US Serial No.: 10/829,049 Docket No.: 0140-4224

<u>Amendment</u>

### <u>REMARKS</u>

The above amendments and following remarks are responsive to the non-final Office Action mailed October 18, 2006. Upon entry of the above amendments, Claims 1, 5, 7, 12, and 22 will have been amended, Claims 2-4 and 13, 14, 16, 17 will have been canceled, without prejudice or disclaimer, and Claims 6, 8, 10, 11, 14, 15, and 18-21 will have been withdrawn as being drawn to a non-elected species. Of the withdrawn claims, Claims 6, 8, and 15 will have been amended to be consistent with the amendments to base Claim 1 to facilitate rejoinder by Examiner upon allowance of Claim 1. Claims 1, 5-12, 15, and 18-22 will be pending. No new matter has been introduced. Entry and reconsideration are respectfully requested.

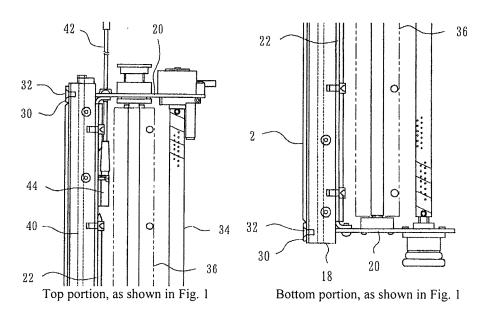
The Examiner has also indicated that

"it is unclear whether the recitation of 'plates 30" on p. 6, line 14 is correct in view of what Figs. 1 and 3 show for numeral **30**. It would appear that "plates 30" should then read –pates 20-- but clarification is respectfully requested. Accordingly, reference **30** in Figs. 1 and 3 would then need to be properly referenced in the specification."

Figure 1 depicts both (1) the side plates 20 of the frame of the cleaning unit and (2) the plates 30 that are engaged with the opposite ends 12 of the base portion 8. Side plates 20 are disclosed, at least on Page 6, Lines 4-6, and depicted in at least Figure 1, as being connected by the back-up bar 22 on which the support bar 18 is mounted. Plates 30, on the other hand, are disclosed, at least on page 6, Lines 13-16, and depicted in at least Figure 1, as being engaged with the opposite ends 12 of the base portion 8, wherein the plates 30, base portion 8, and the

support bar 18 are fixed to each other by means of screws 32. The Examiner's attention is directed to the portions of Figure 1 included below in which side plates 20 are connected to the support bar 18 via back-up bar 22, and plates 30 are connected to the support bar 18 on a side opposite to side plate 20.

Since side plates 20 and plates 30 are disclosed and depicted as separate elements, Applicant respectfully submit that no amendments to either the specification and/or drawings is necessary.
